**Notification of a Decision taken by the Cabinet Member for
Regeneration, Environment and Housing**

Subject: Balfour Road Experimental Road Closure

**EXPERIMENTAL ROAD CLOSURE,
BALFOUR ROAD, LB MERTON**

**STAGE 1/2 - ROAD SAFETY AUDIT
NOVEMBER 2015**

BALFOUR ROAD – EXPERIMENTAL ROAD CLOSURE

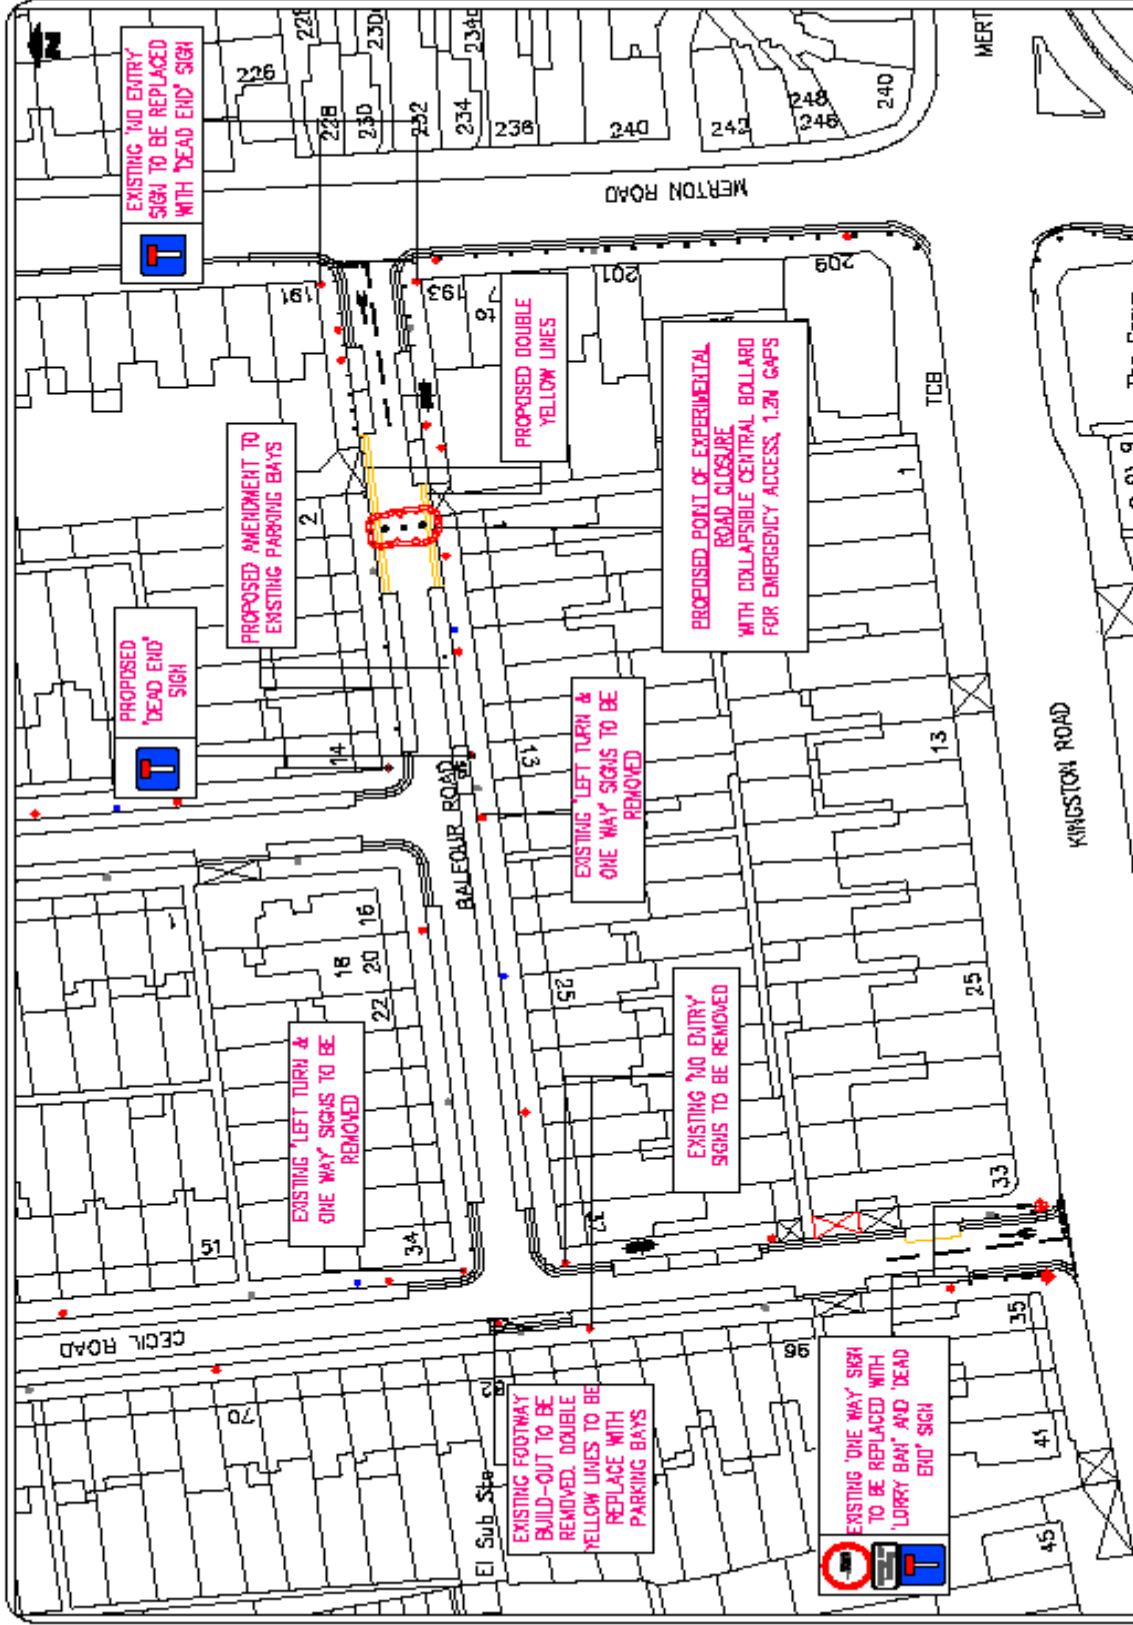
2.1 The introduction of the bollards may result in there being insufficient turning provision adjacent to the bollards for a significant number of users including residents especially those parked within the parking bays adjacent to the bollards, potential HGVs/MGVs associated with the commercial premises or refuse vehicles either side of the bollards. This issue may result in injudicious turning and/or reversing manoeuvres over an excessive distance that may lead to a number of road safety issues at this location including:

- Vehicles having to reverse onto Merton Road into the path of on coming traffic which could include HGVs/MGVs associated with the commercial premises accessed from Balfour Road;
- Vehicles having to reverse onto Cecil Road (east) which may result in increased levels of conflict at this junction; and
- Potential multi-point turning manoeuvres where a sufficient turning head is not provided.

2.3 It is also noted that the area adjacent to the bollards where vehicles would be required to turn is adjacent to a nursery which may exacerbate the problems identified above and potentially increase the risk of vehicular collisions with vulnerable road users.

- 2.6 At both the Balfour Road (east) and Balfour Road (west) junctions with Cecil Road there are no details provided with regard to the give-way road markings at these locations. A lack of appropriate road markings at these locations could lead to side-swipe type collisions at these locations. It is noted that give way road markings are currently provide at both junctions, albeit that they are extremely worn at the Balfour Road (east)/ Cecil Road junction.

2.4 Ensure suitable turning facilities are provided for vehicles to safely turn either side of the bollards.

2.5 It is noted that double yellow lines are provided in advance of the bollards which allows for increased width for turning vehicles, however vehicle swept path analysis should be

undertaken using the largest vehicle size anticipated to use Balfour Road to ensure the layout is satisfactory with regard to the problem raised.

- 2.7 Ensure give-way road markings are provided at both the Balfour Road (east) and Balfour Road (west) junctions with Cecil Road.
